CFC Percy St. Auburn

13 Percy Street, Auburn, NSW 2144

S4.55 - AMENDMENT LIST

ISSUE FOR S4.55

Drawing Title:
Site Plan

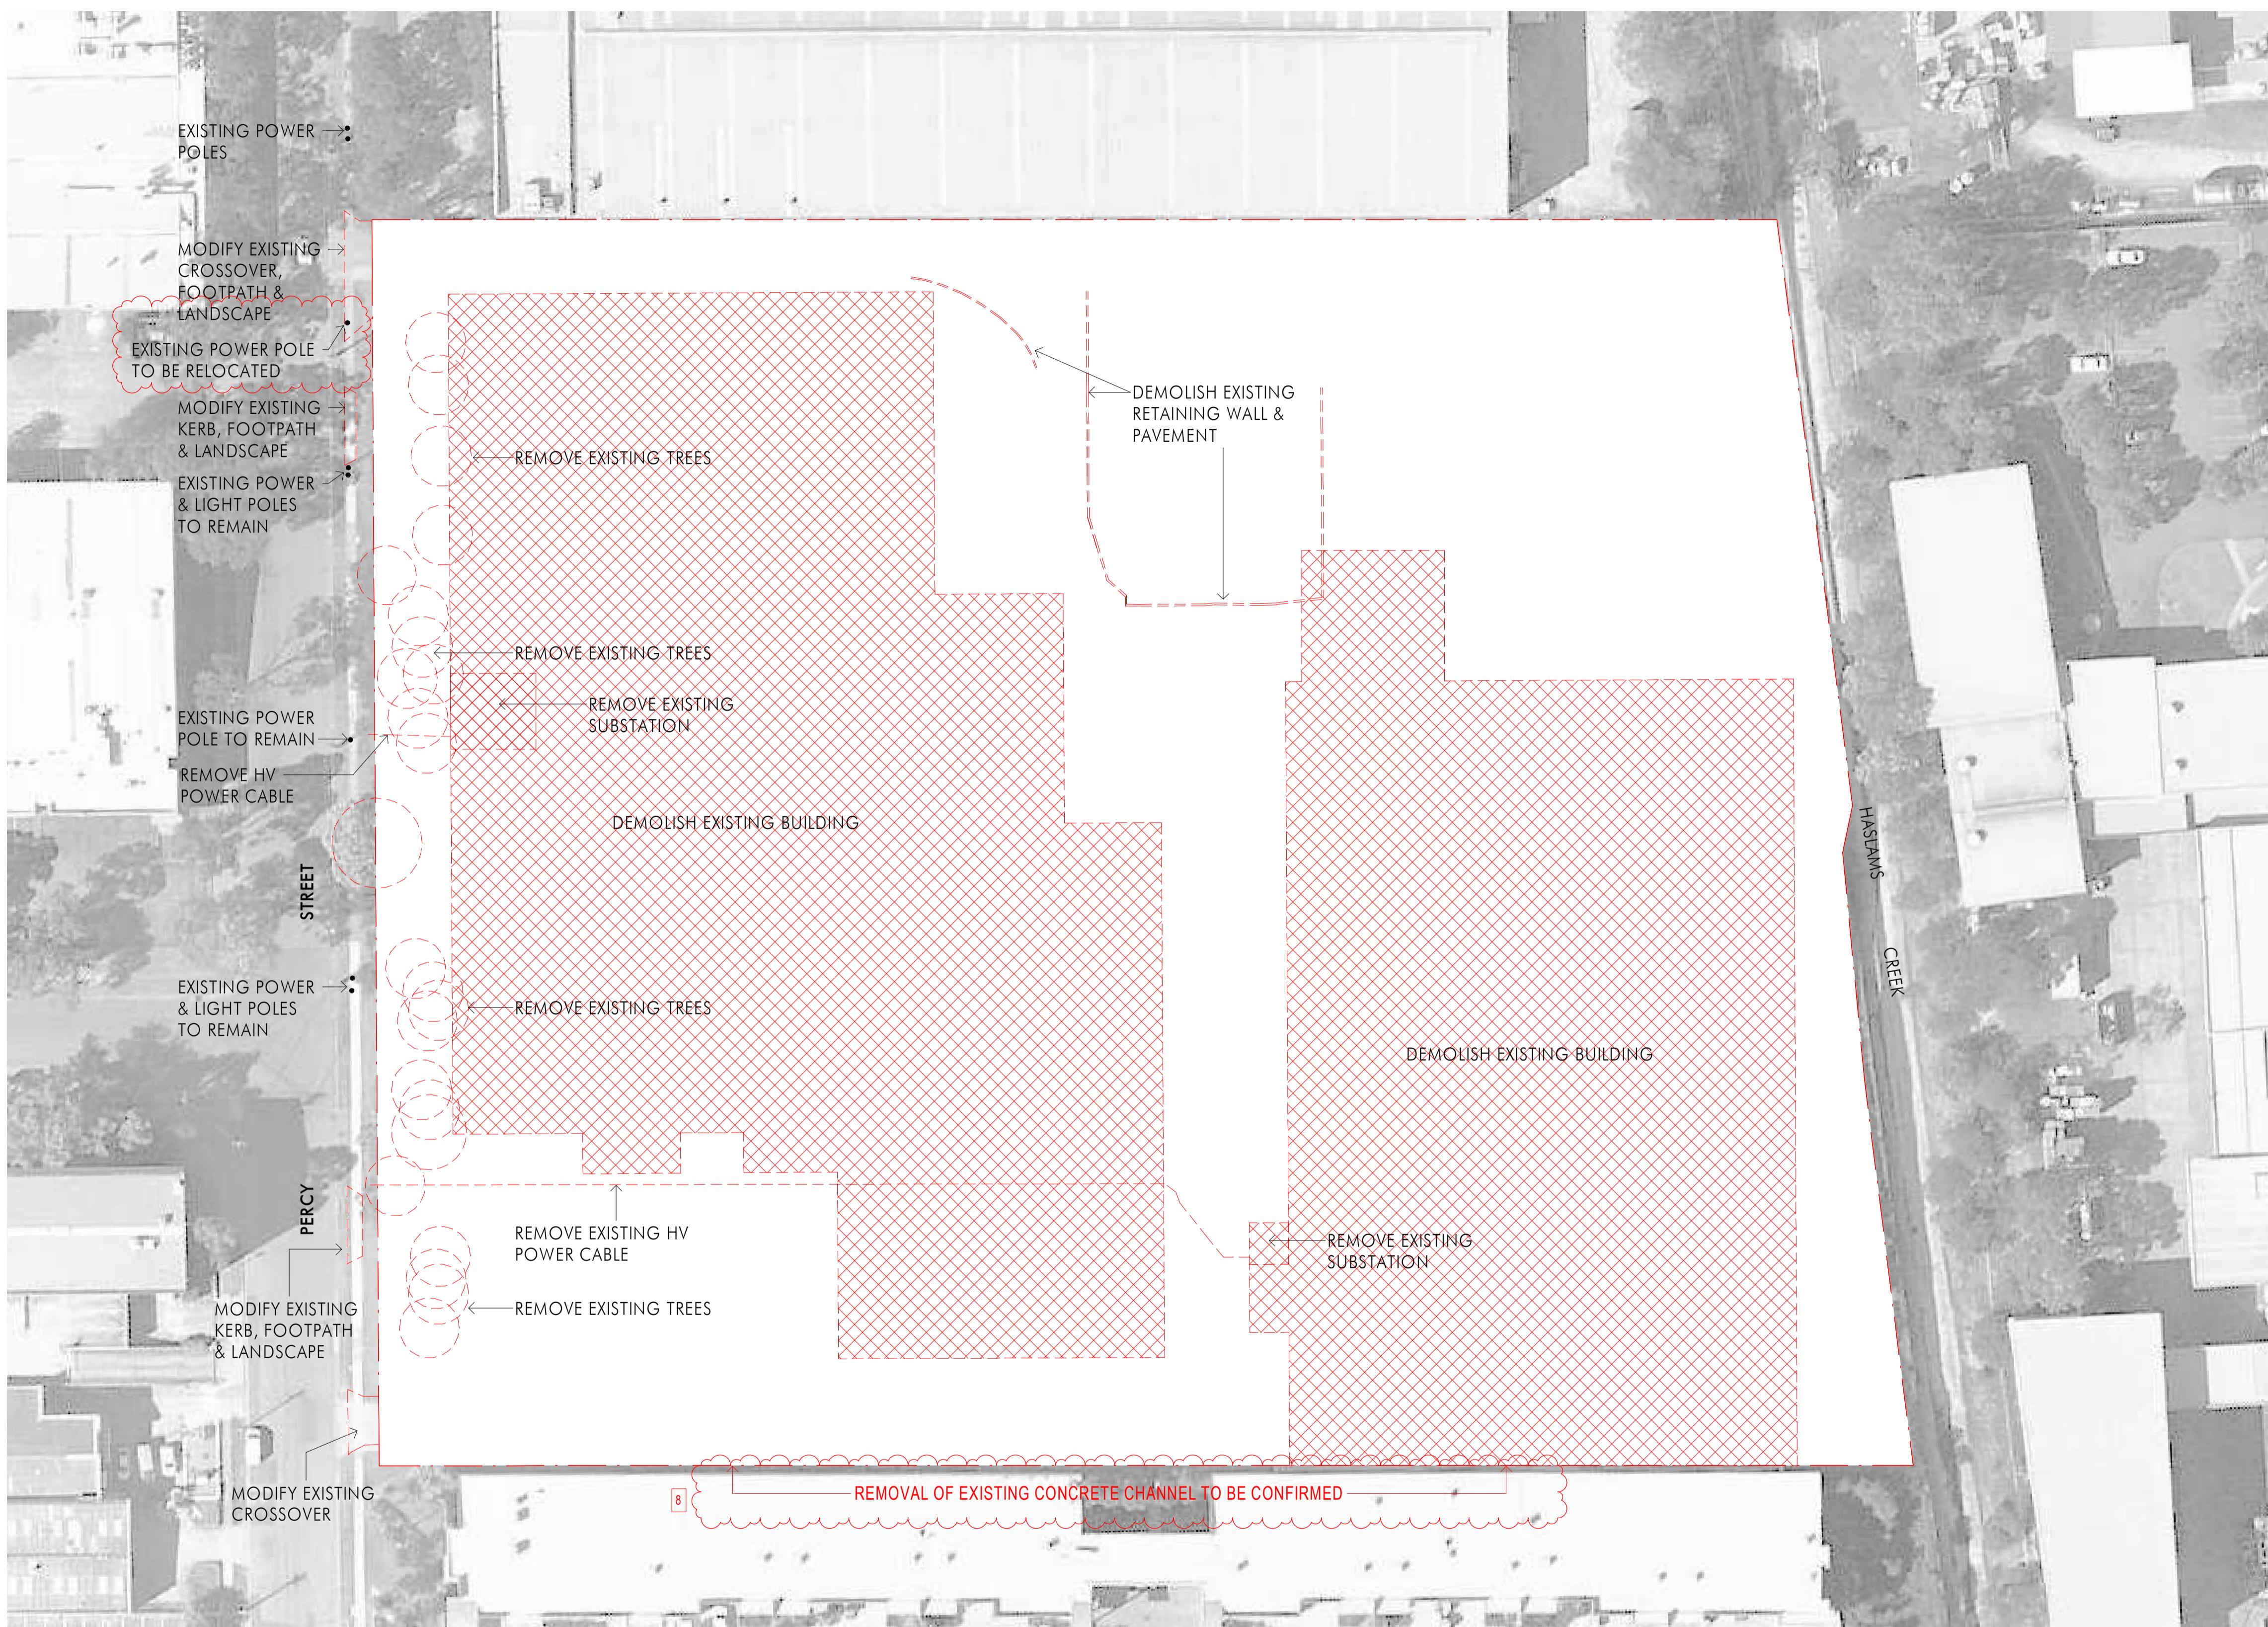
1. Carpark layout change due to additional mech. plant rooms & boomgate
2. Extension of roof over L1 office entry
3. Added external egress stair, awning over DTB bays and plant deck

4. Added external egress stair to access mezz. floors and roof
5. Added mech. exhaust & plant on roof & removed translucent roof sheets
6. Inbound dock awning is reduced

7. Added mech & refrigeration plant rooms on rear elevated plant deck, and associated egress stair
8. Added removal of existing concrete channel in demolition

9. Additional DTB store and DTB bays, including changed configuration of DTB bays
10. Office internal layout amended
11. Added landscape area, aluminium screen & gates

12. Southern plant area layout changed as following
 - Minor change to solar and switch room layout
 - Sub & HVC updated
 - Permanent generator reduced to single large gen. Portable gen is added

- Diesel tank is added for backup generators
 - Armc is added around sub & sprinkler plant area
13. Precast wall is erected higher to support the rear elevated plant deck

14. Maintenance and wash bays are added
15. Added an external stair to inbound dock area
16. Security gates added
17. Boom gates added
18. Minor enlarged L1 office lobby & additional stair next to rec area

19. NOT USED
20. Mech. Louvre added
21. Heavy duty guardrail added to suspended slab edges
22. Replaced transparent wall sheathing to Longline metal cladding

23. Pickup graphic extended
24. CFC sheeting is removed from Office ground elevation
25. NOT USED
26. Outbound Loading dock size & Van parking size increased (TBC)

27. Two mechanical plant rooms on carpark level added
28. Added 3 flag poles
29. Added 2 lightning poles
30. Added generator on slab above switch and solar rooms

Drawing Title:
Demolition Plan

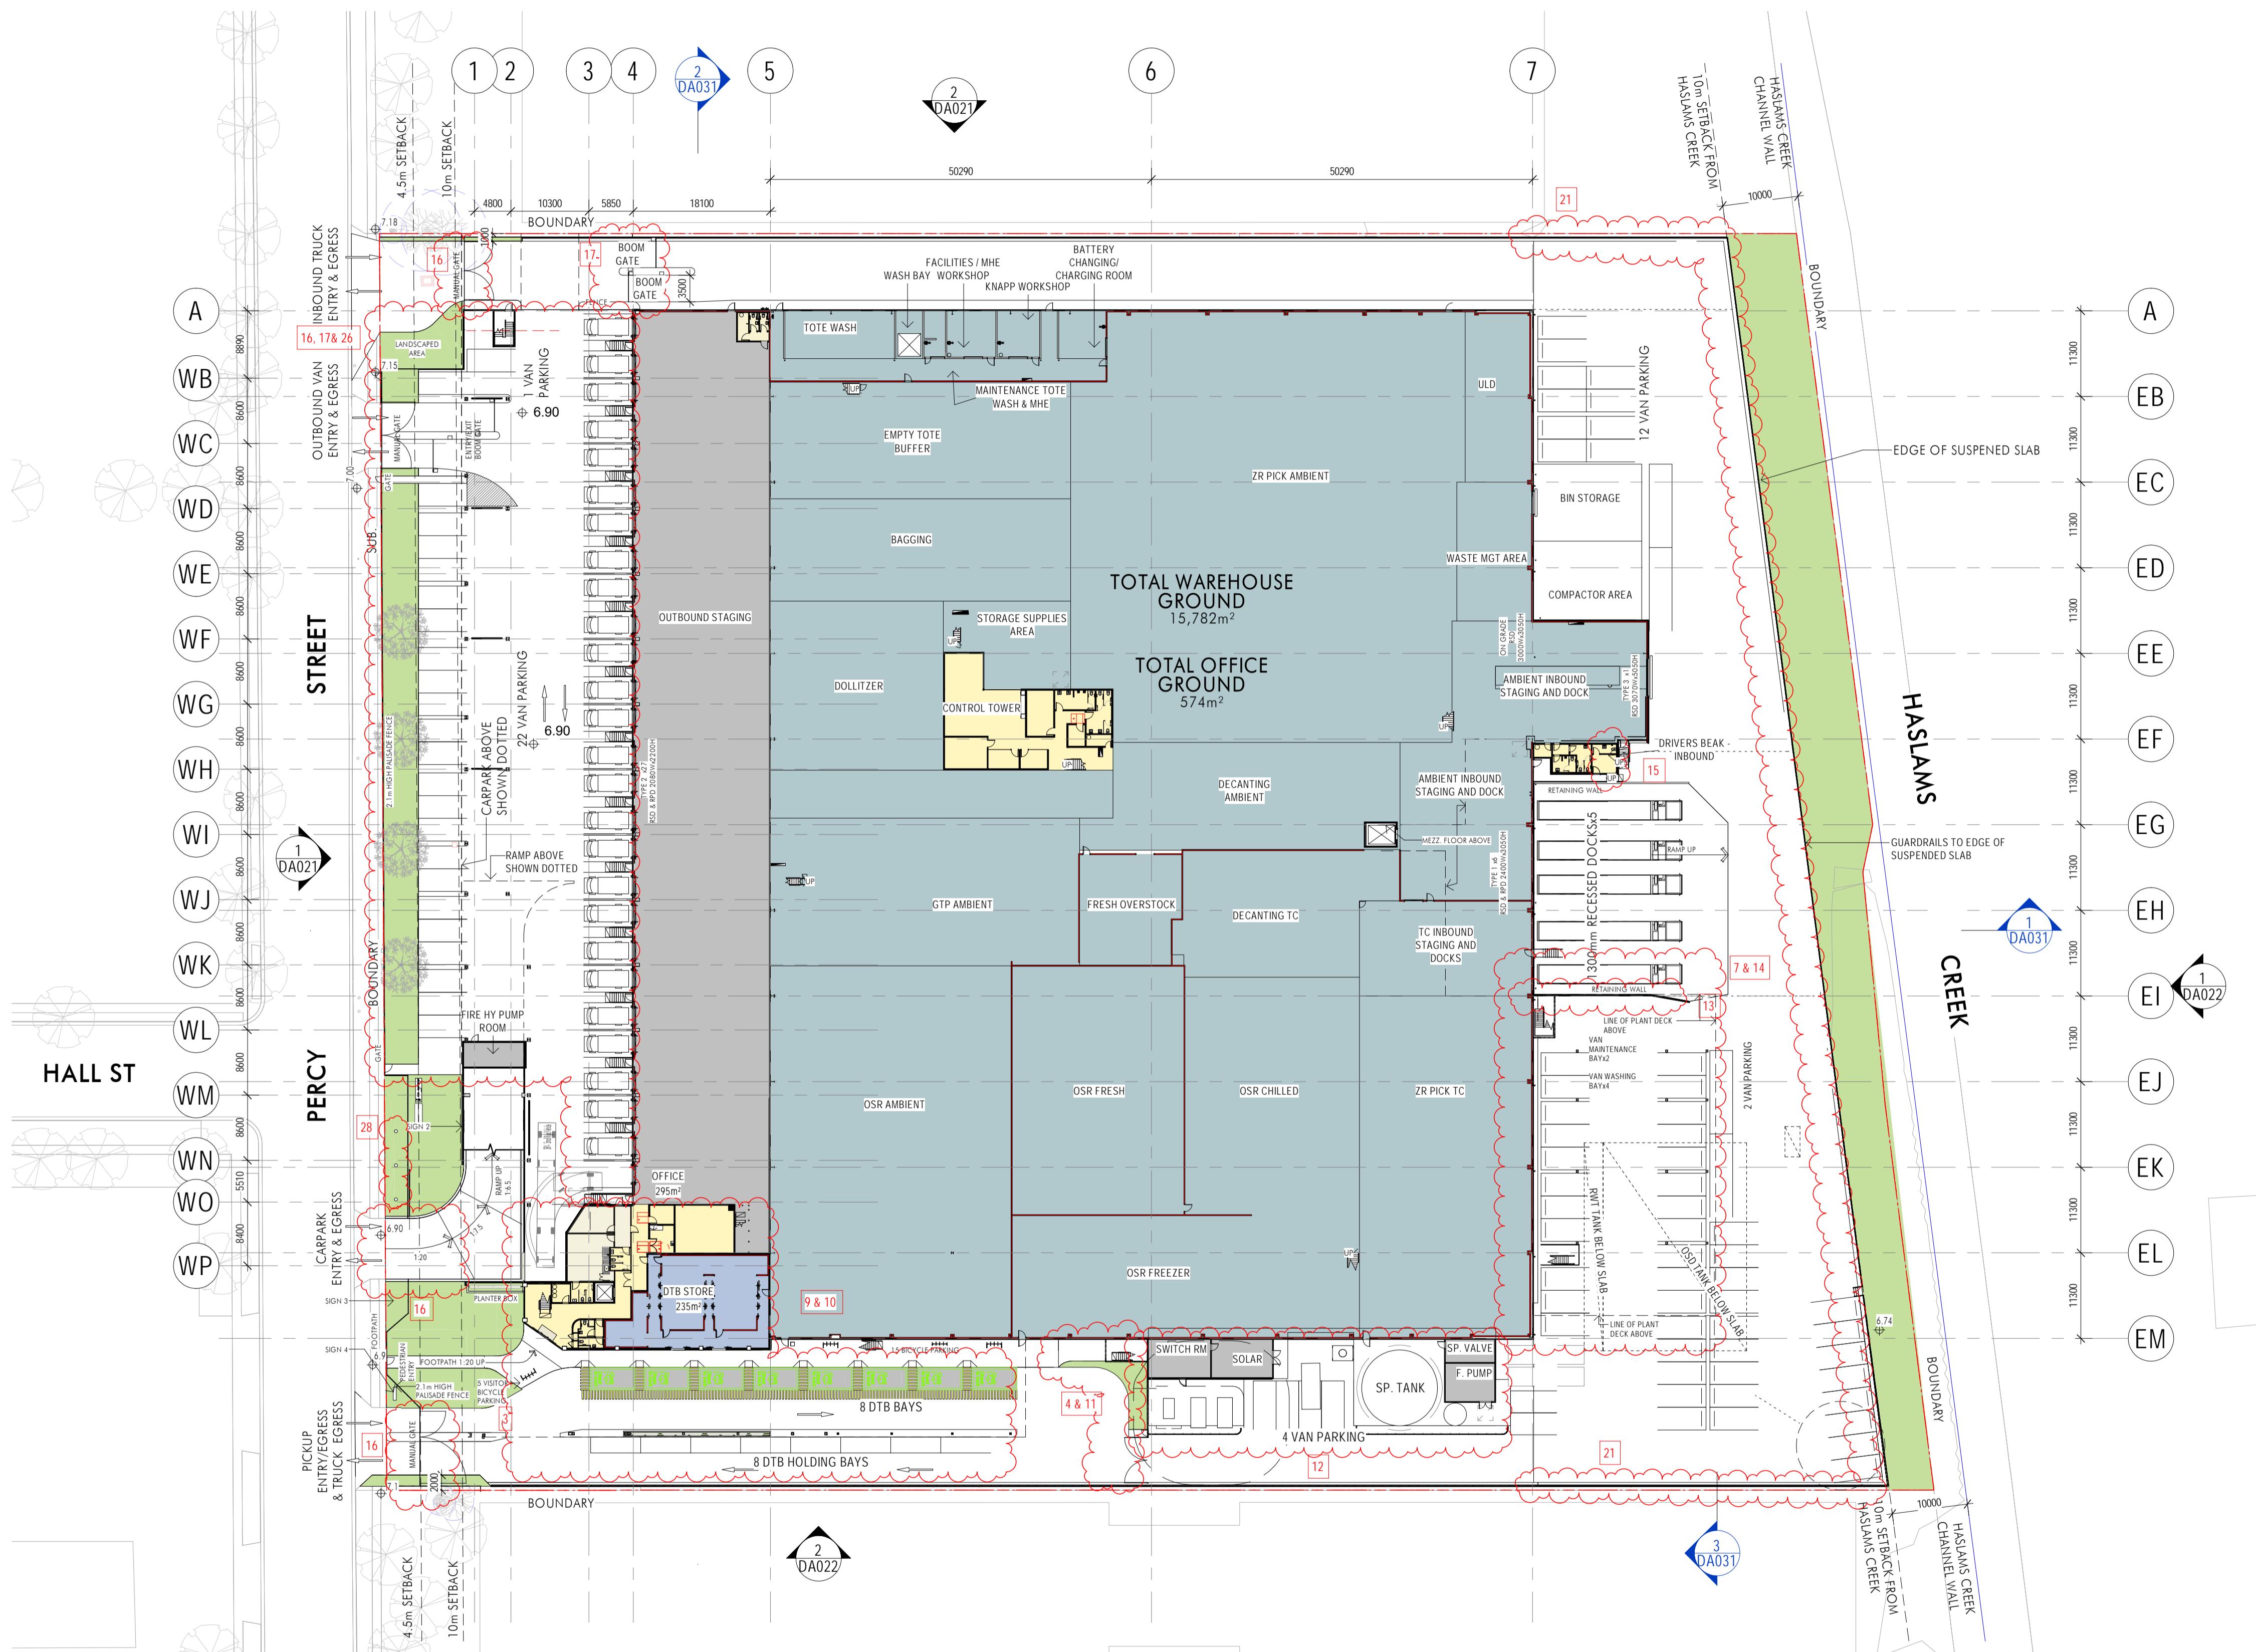
7. Added mech & refrigeration plant rooms on rear elevated plant deck, and associated egress stair
8. Added removal of existing concrete channel in demolition
